06-16-2021 Town Council Meeting Responses to Council Questions

ITEM #8: Consider an Application for Conditional Zoning - Aura Development, 1000 Martin Luther King Jr. Blvd. from Residential-1 (R-1) to Office/Institutional-3 (OI-3)

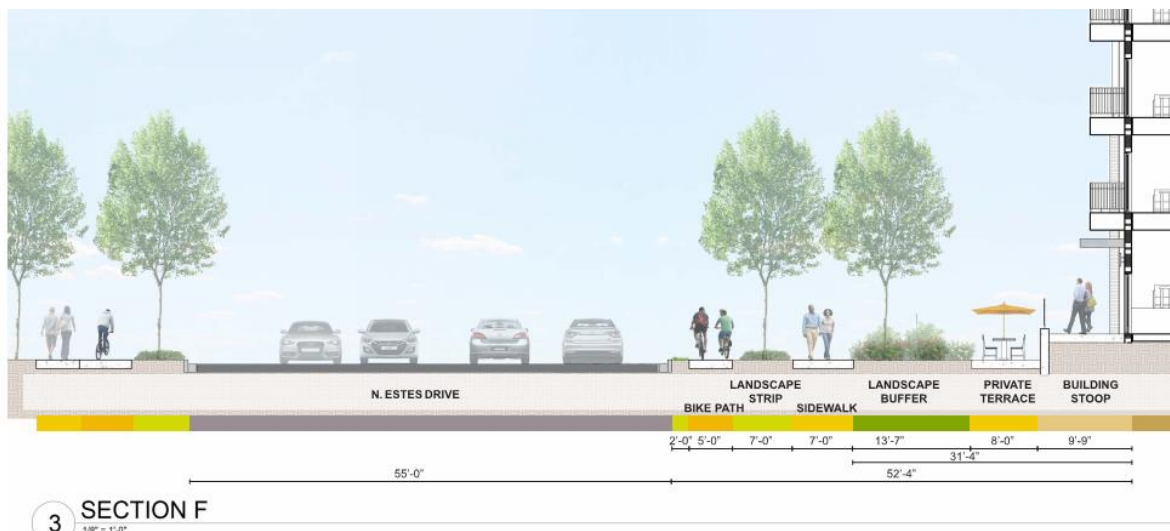
If DOT does not agree to a stoplight at Somerset, could we re-look at the plan for a parallel street connecting to Somerset as proposed in Central West? What are the pros and cons of that plan?

The Revised Ordinance A for the Aura development includes a cross-access easement to connect the Aura property with the Rummel property to the east. It is possible that in the future the two properties are connected. The connection would not occur until the Rummel project was developed. Staff could use the town-wide model to determine impacts of that connection.

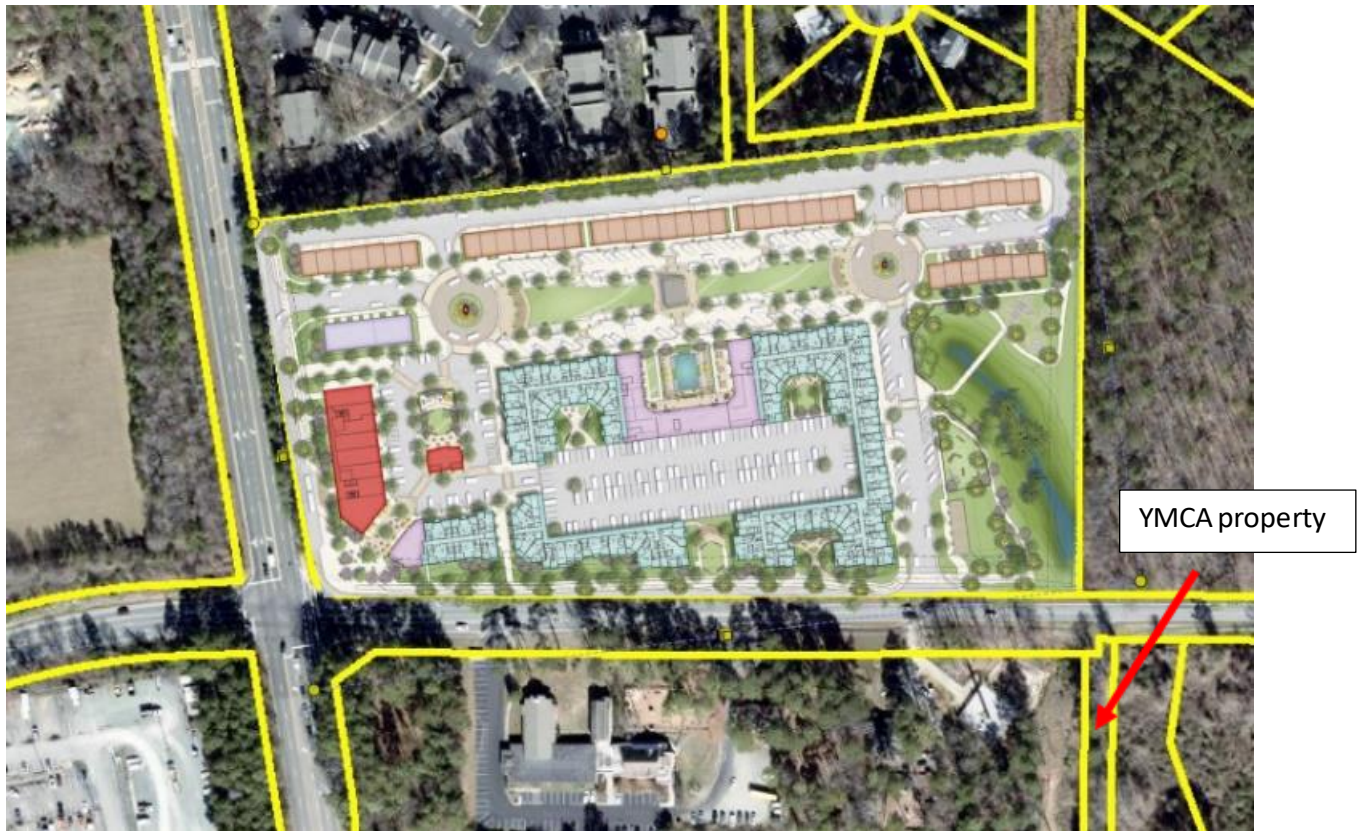
Is the Aura entrance aligned with the proposed new YMCA entrance?

The image below shows the Aura entrance would be off-set from the YMCA entrance. The YMCA property is east of the eastern edge of the Aura property (across from the Resource Conservation District).
